PILGRIM WATCH

June 14, 2012

SUBJECT: Fukushima Lessons Learned Tier 3 Recommendations- Spent Fuel Pool vs. Dry Storage; Reliable Hardened Vents & Filtration of Containment Vents; Emergency Planning Issues, Expanding Size EPZ, Pre-staging Potassium Iodide Beyond 10 Miles, Monitoring; and Relegating Recommendations To Backfits

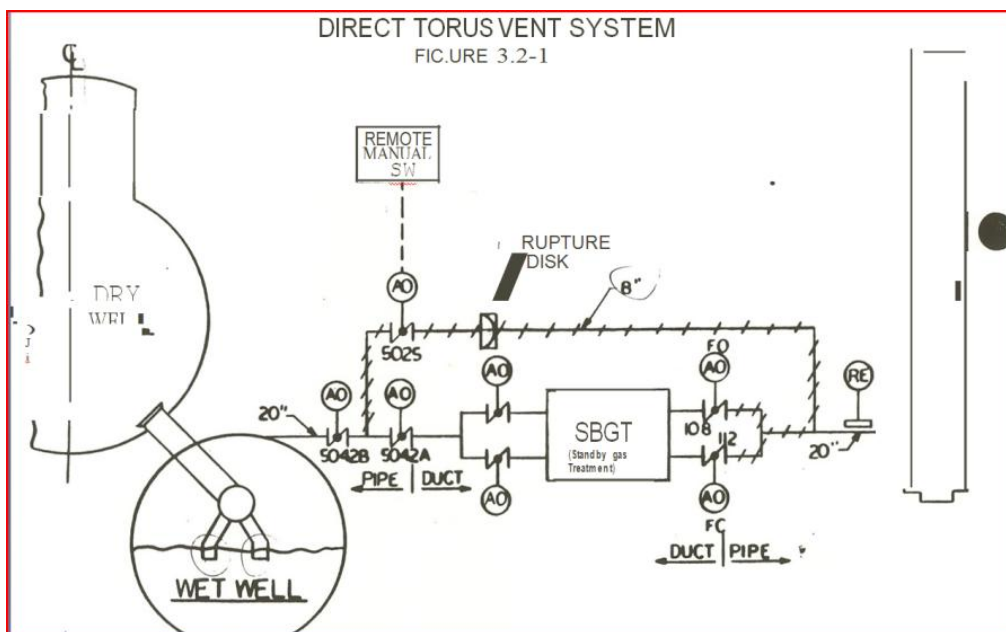
The DTVS provides a new 8" line branching off the existing torus purge exhaust line between the containment isolation valves (outside containment) with a reconnection to the existing torus purge exhaust line downstream of the SGTS. The new torus vent line is also provided with its own containment isolation valve and rupture disc, set to relieve at 30 psig.

The following diagram, that shows the branch line with its own containment isolation valve 5025 and Rupture Disc, is included in the attachment to BECO's letter. It will be noted that the Rupture Disc is downstream of valves AO-5042B and AO-5025, and that both of these valves are normally closed and are designed to be opened either remotely from the control room or manually.²⁰

- An 8" butterfly valve (AO-5025), which can be remotely operated from the control room, is added downstream of 8" valve AO-5052B. This valve acts as the primary containment outboard isolation valve for the DTV line. Test connections are provided upstream and downstream of AO-5025.

- AO-5042B was replaced in 1988 with a DC solenoid valve (powered from essential 125 volt DC) so that it would operate without dependence on AC power. AO-5025 is also provided with a DC solenoid powered from a redundant 125 volt DC source. Both valves are normally closed and are closed in a "fail-safe" position. One inch nitrogen lines are added to provide nitrogen to valves AO-5042B and AO-5025.

- A rupture disc is included in the piping to provide a second leakage barrier. It is designed to open below containment design pressure, but will remain intact up to pressures equal to or greater than those which cause automatic containment isolation during accident conditions.
